AGENDA
PLAN COMMISSION MEETING
Thursday, January 6, 2022 at 7:00 p.m.
Jackson Municipal Complex
Village Board Room
N168 W19851 Main Street
Jackson, WI 53037

1. Call to Order and Roll Call
2. Approval of Minutes for the Plan Commission Meeting of December 2, 2021
3. Conditional Use Amendment – Morning Star Lutheran Church – Early Childhood Learning Building Addition – N171W20131 Highland Road
4. Citizens to Address the Plan Commission
5. Adjourn

Project: Morning Star Early Childhood Center Addition
N171 W20131 Highland Rd
Jackson, WI 53037

Plan Commission December Meeting – January 6, 2022

A1.2

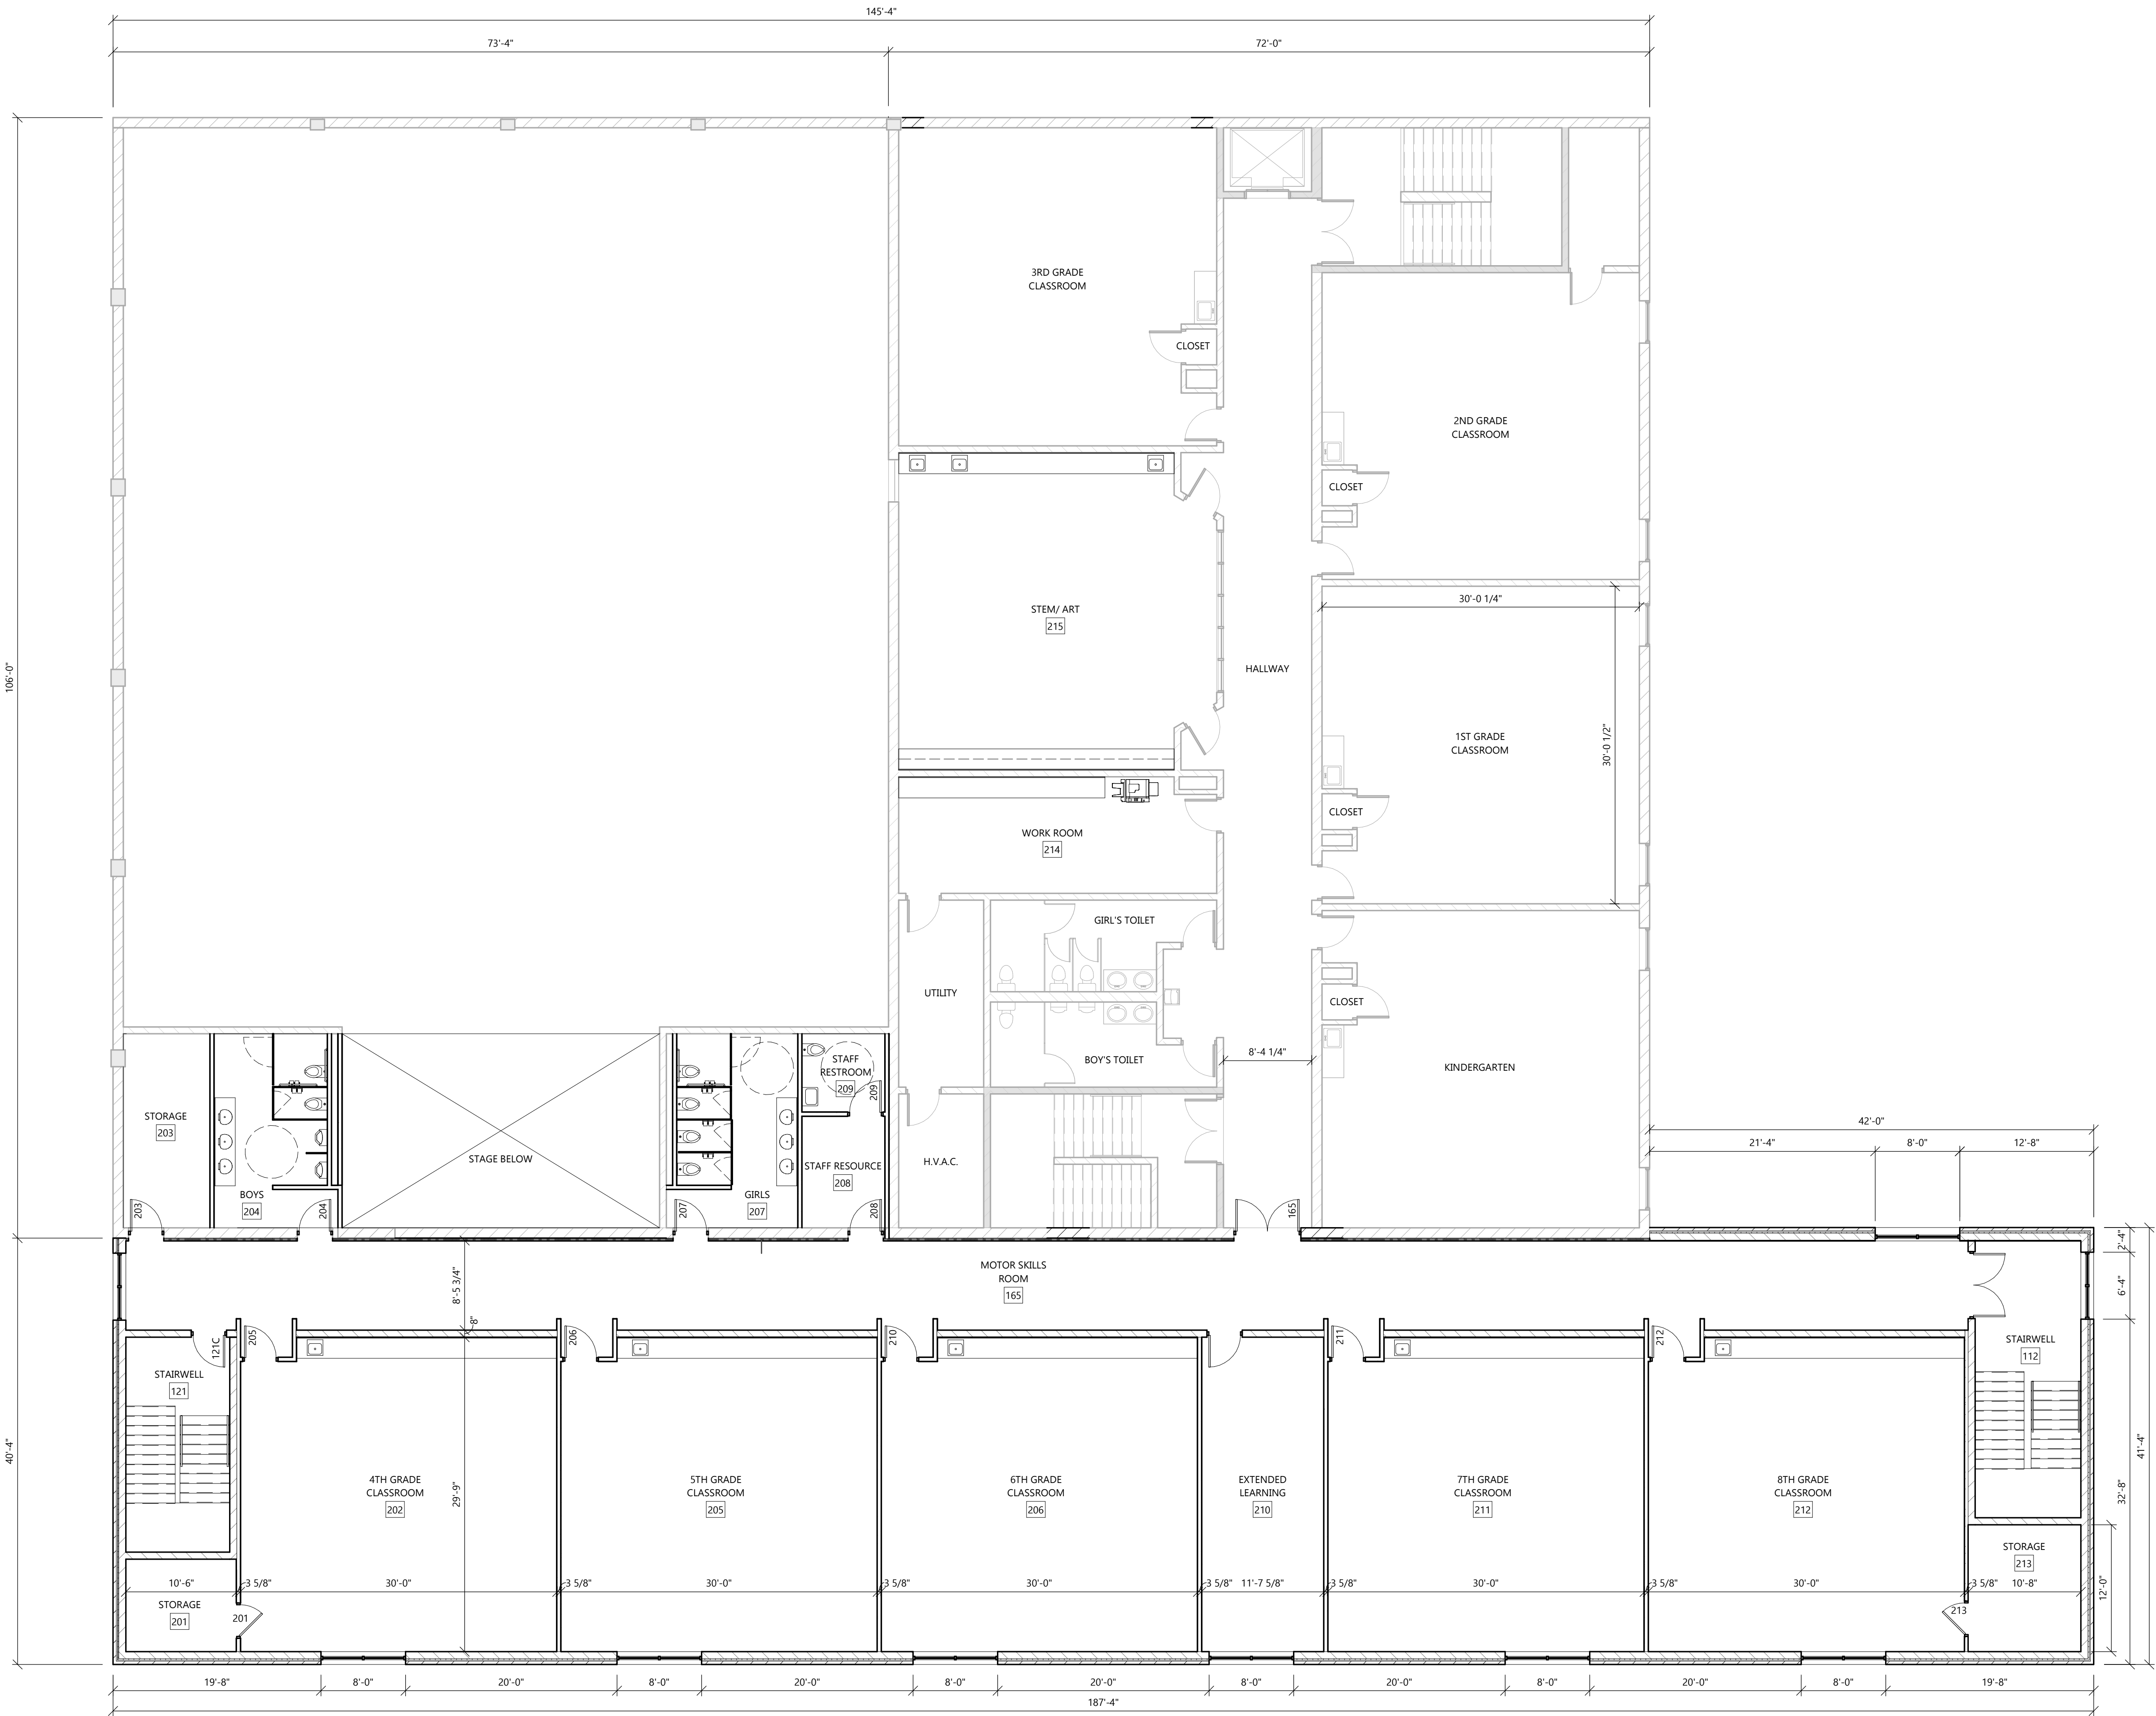
- Building plans do not disclose full construction details or proposed occupant loads so it is not possible to determine how the designer intends to meet the exception for not sprinklering the addition given the fact that the addition area exceeds the exceptions in both IBC 903.2.1.3 and 903.2.3.

- Fire sprinkler system may be needed in new addition as square footage of addition is over 12,000 square feet.
- State approved plans will be required.
- Fire Hydrant needed on south side of building.
